CALL NO. 103
CONTRACT ID NO. 181025
ADDENDUM # 3

Subject: BOONE COUNTY, STP 8200(017)
Letting July 27, 2018

- (1) Revised - Proposal Bid Items - Pages 237-243 of 243
- (3) Revised - Plan Sheets - R2g, T13, T14, and T16

| SHEET NO. | T14 | |

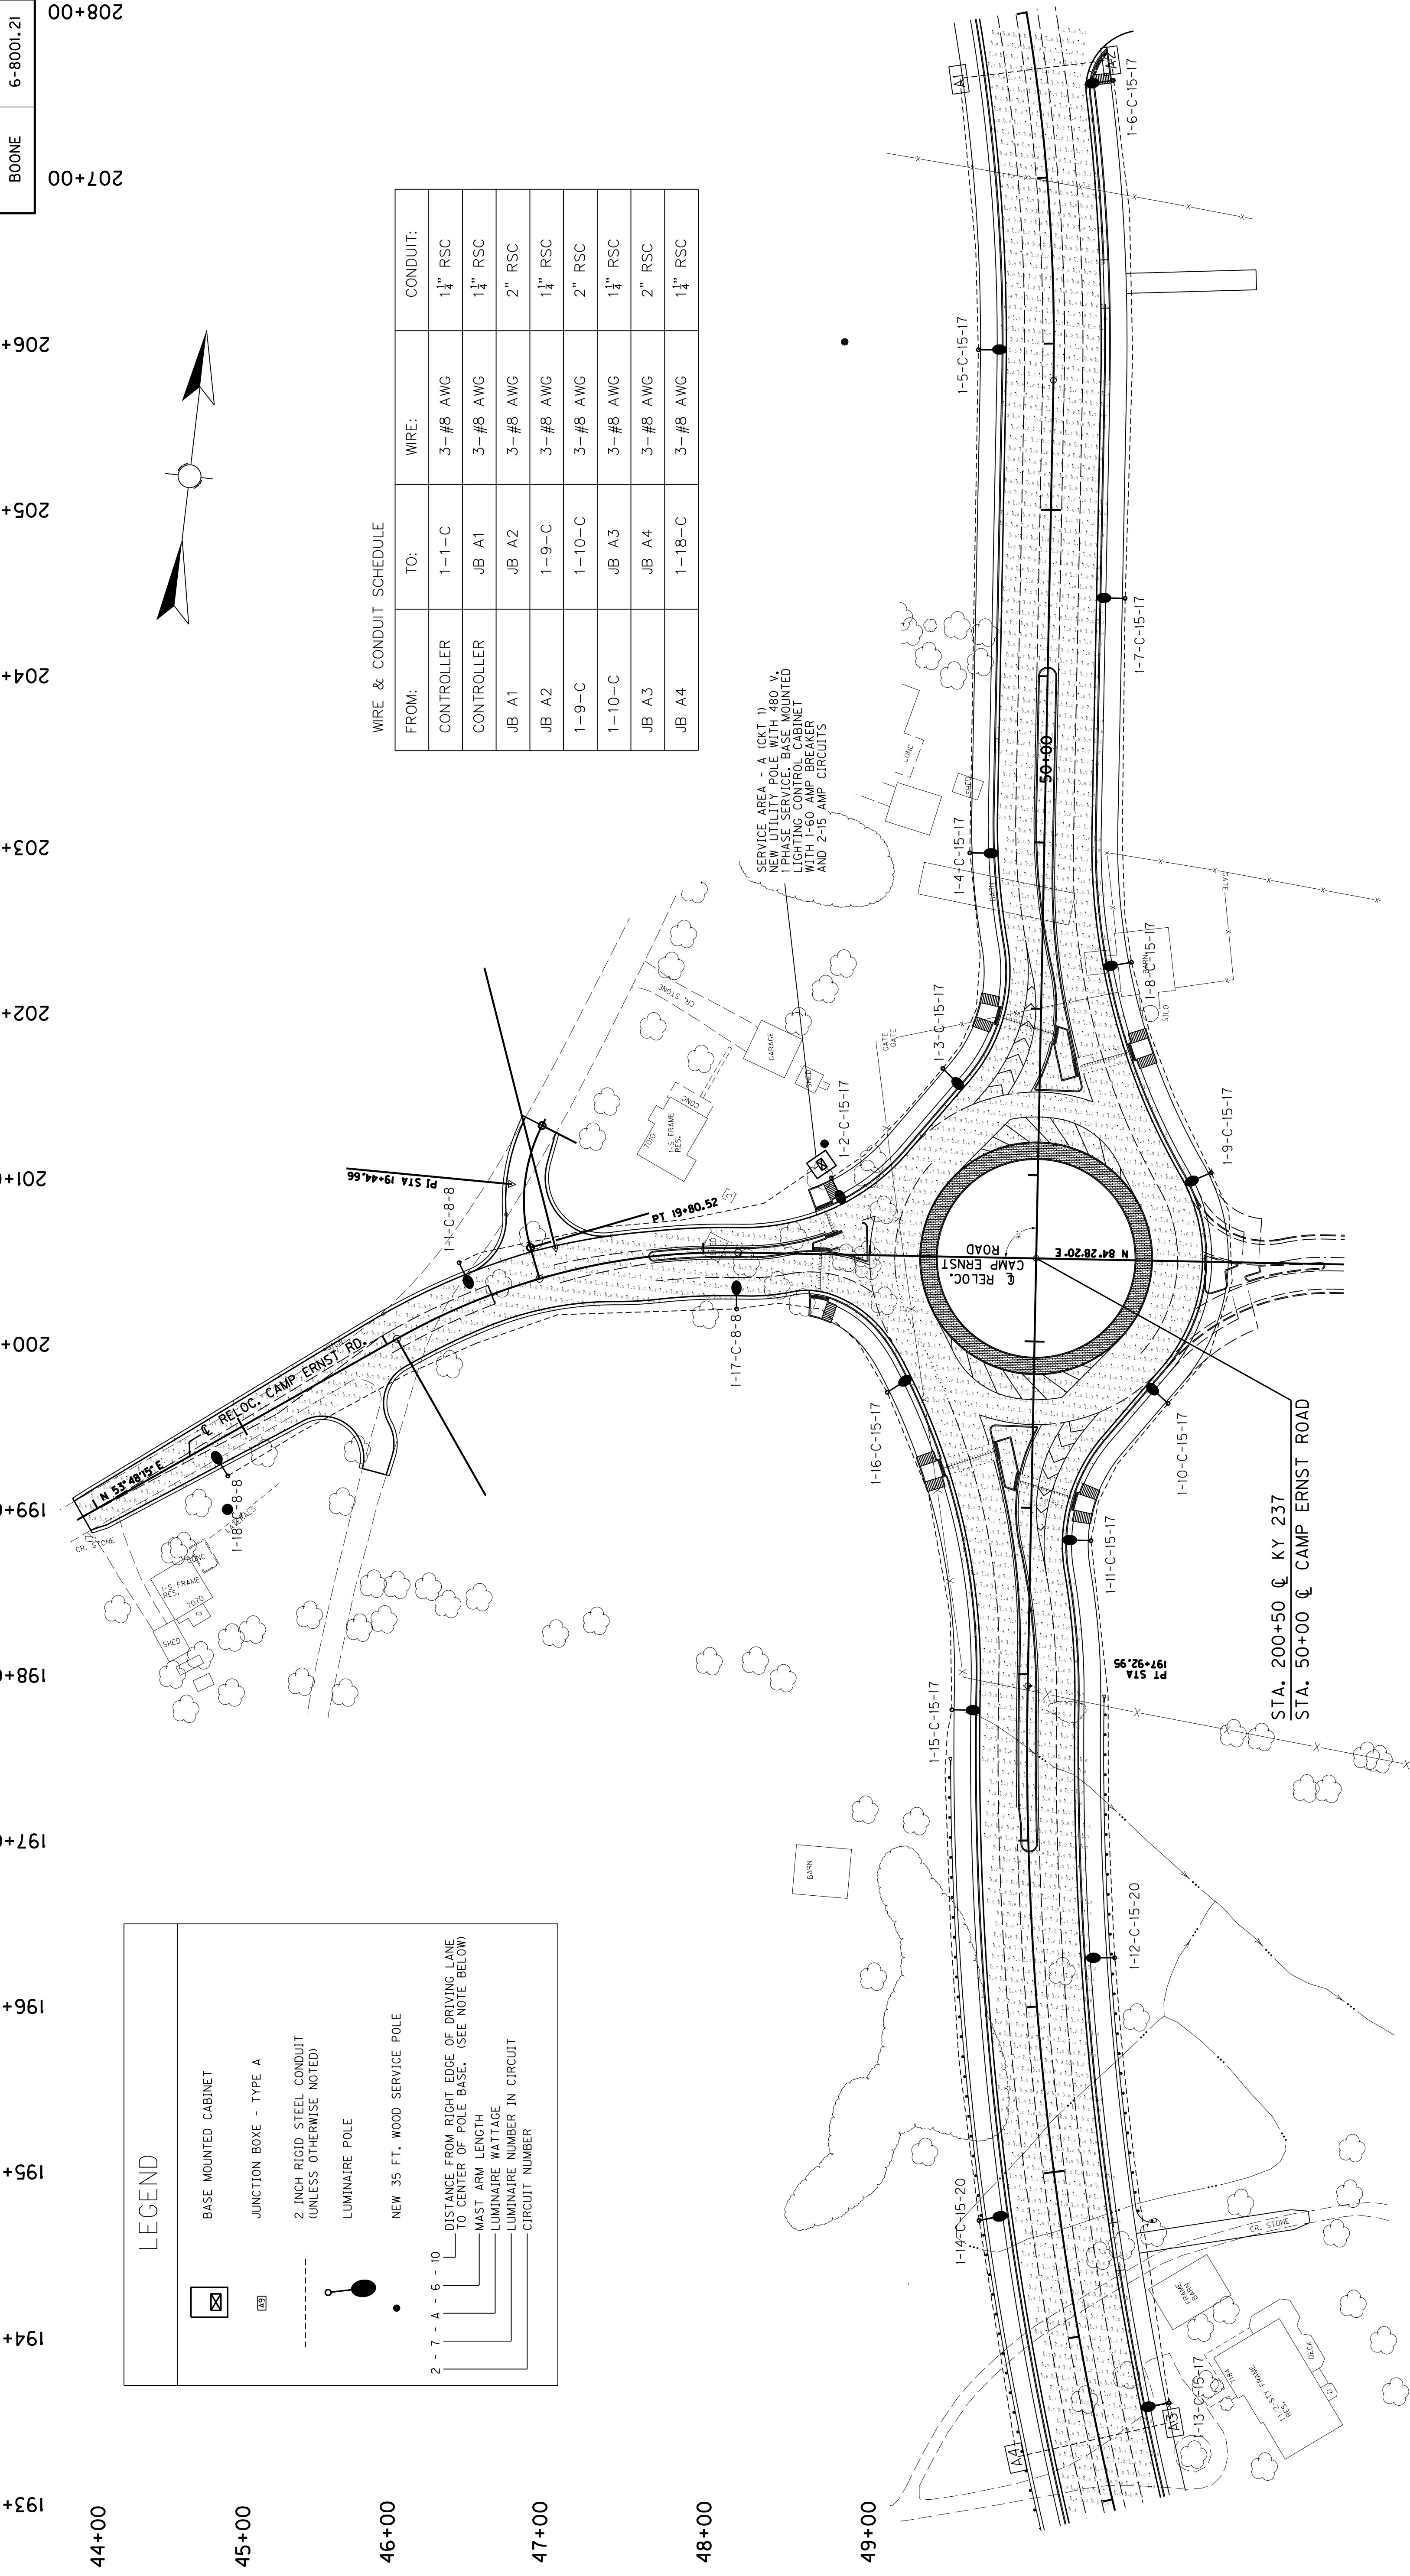
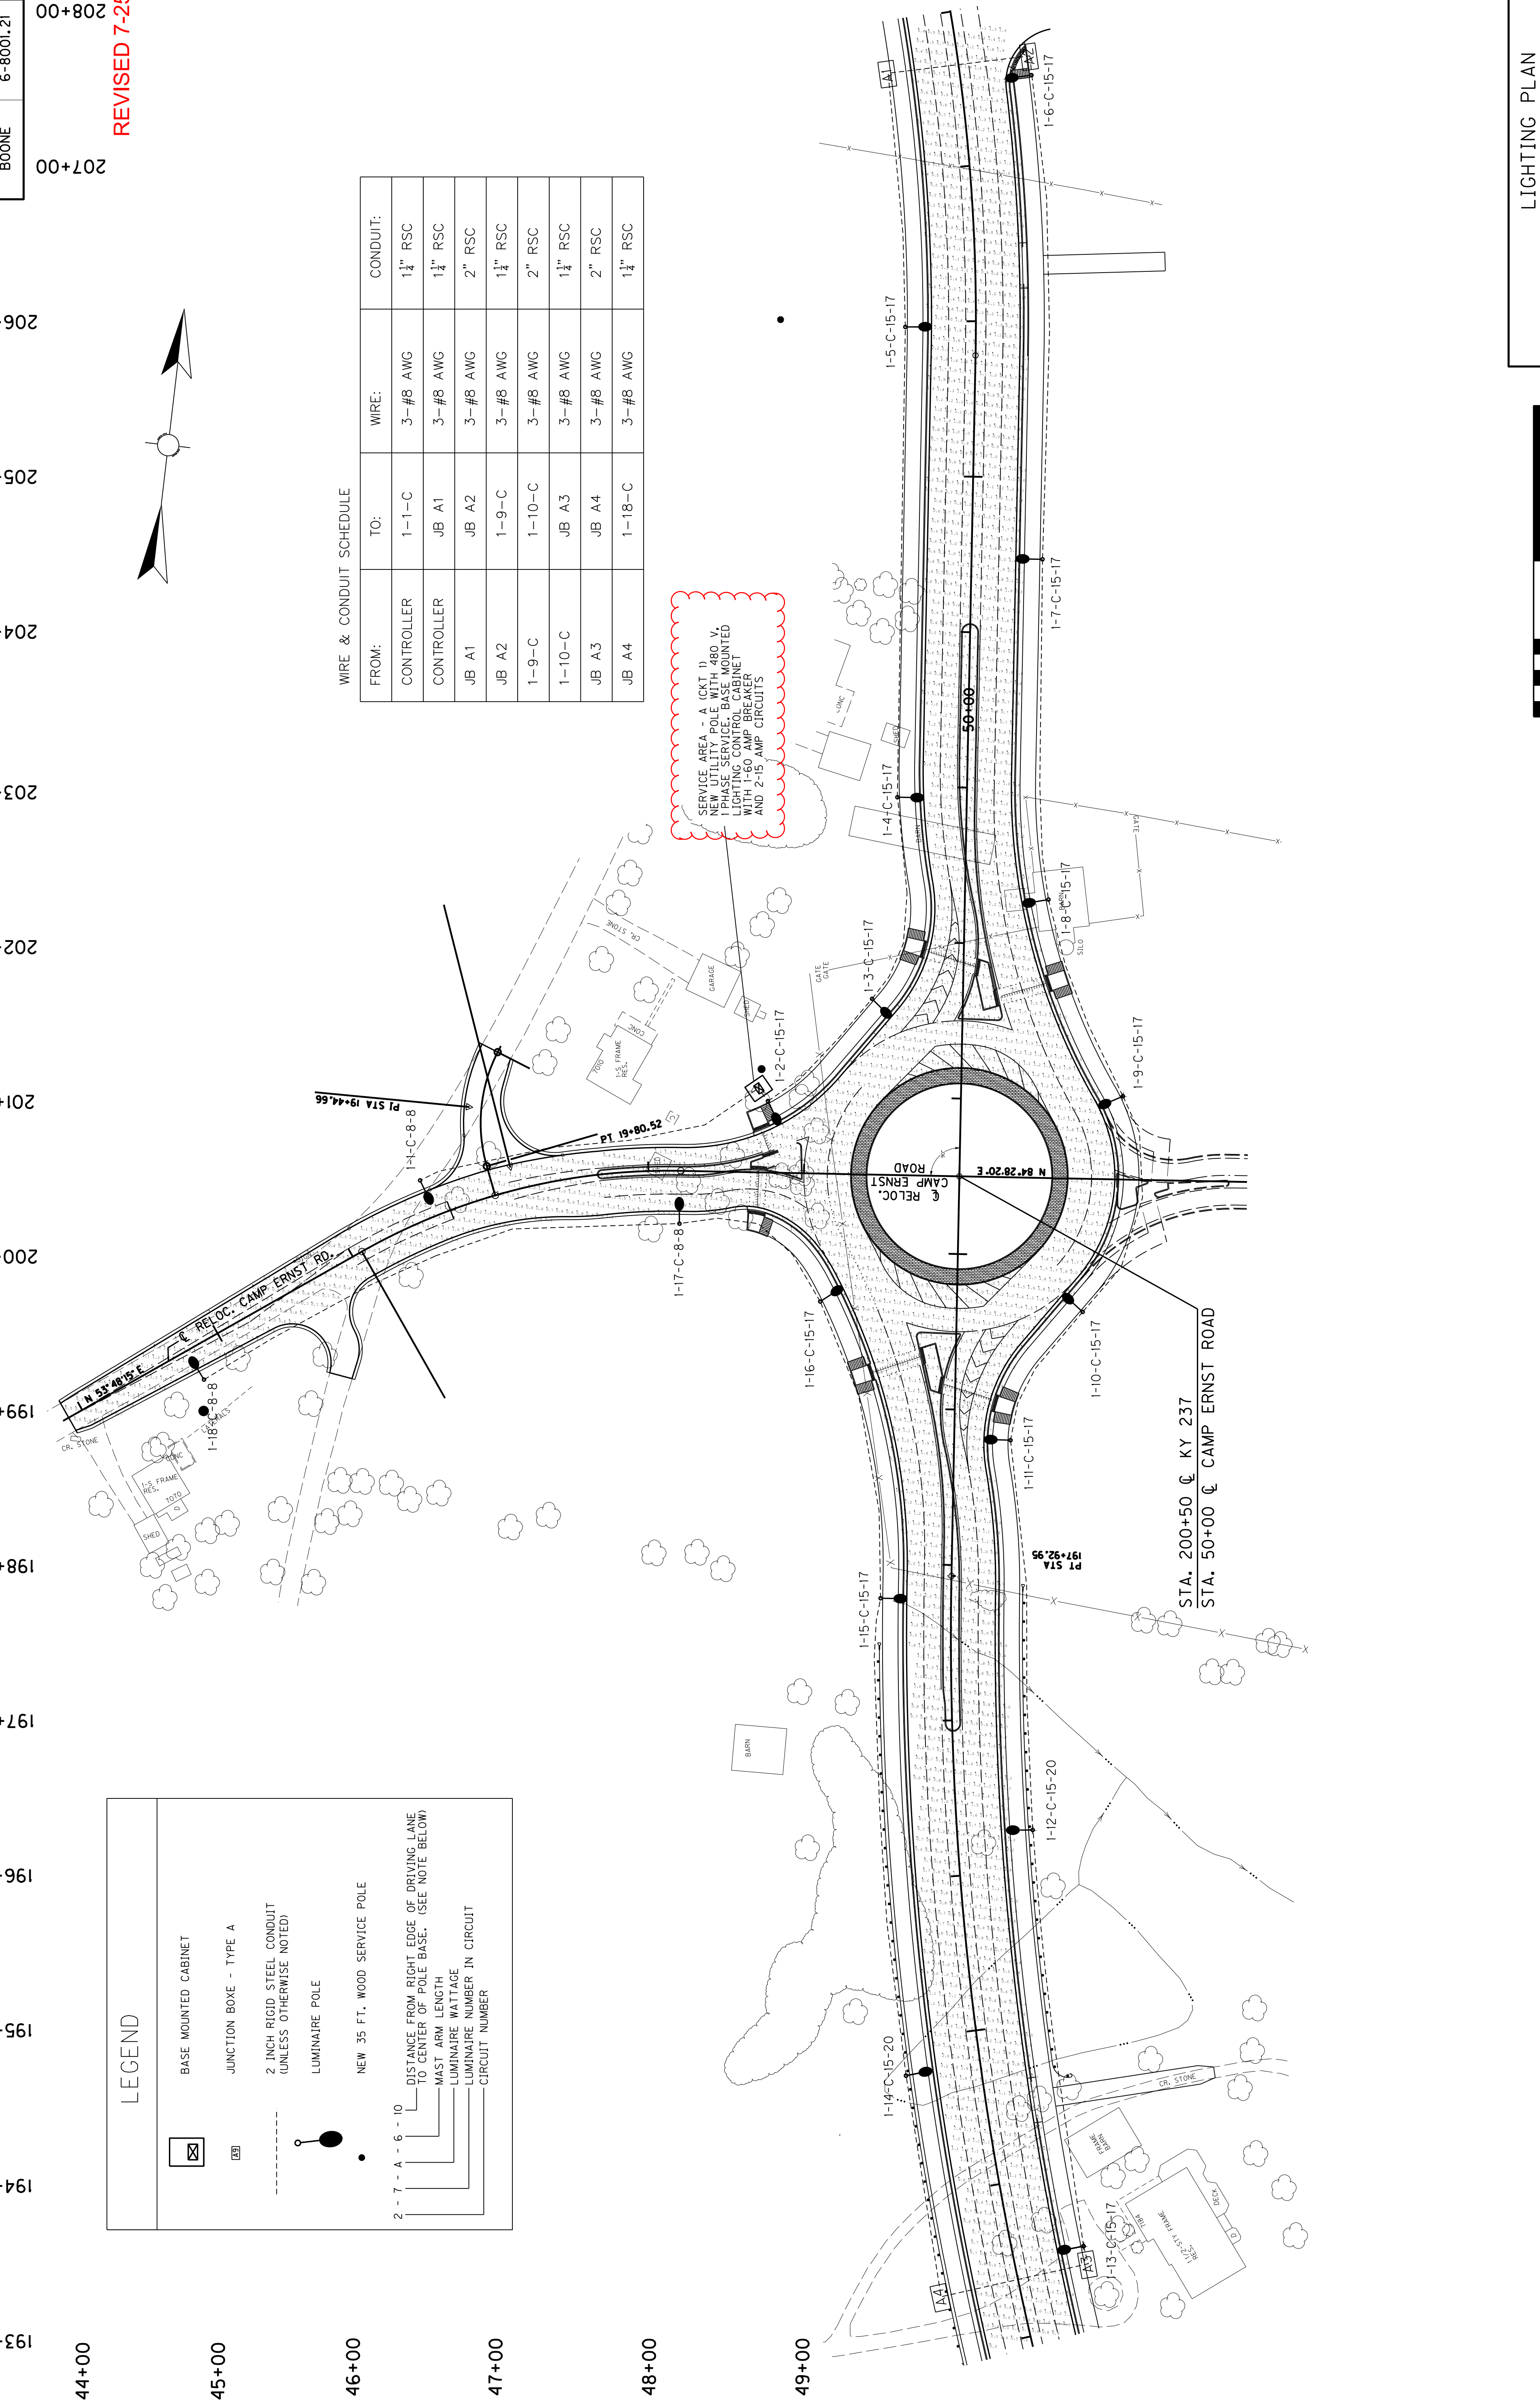
SERVICE AREA - A (CMT 1) SERVICE POLE WITH 1-180-V 1-PHASE SERVICE, BASE MOUNTED LIGHTING CONTROL CABINET WITH 1-60 AMP BREAKER AND 2-15 AMP CIRCUITS
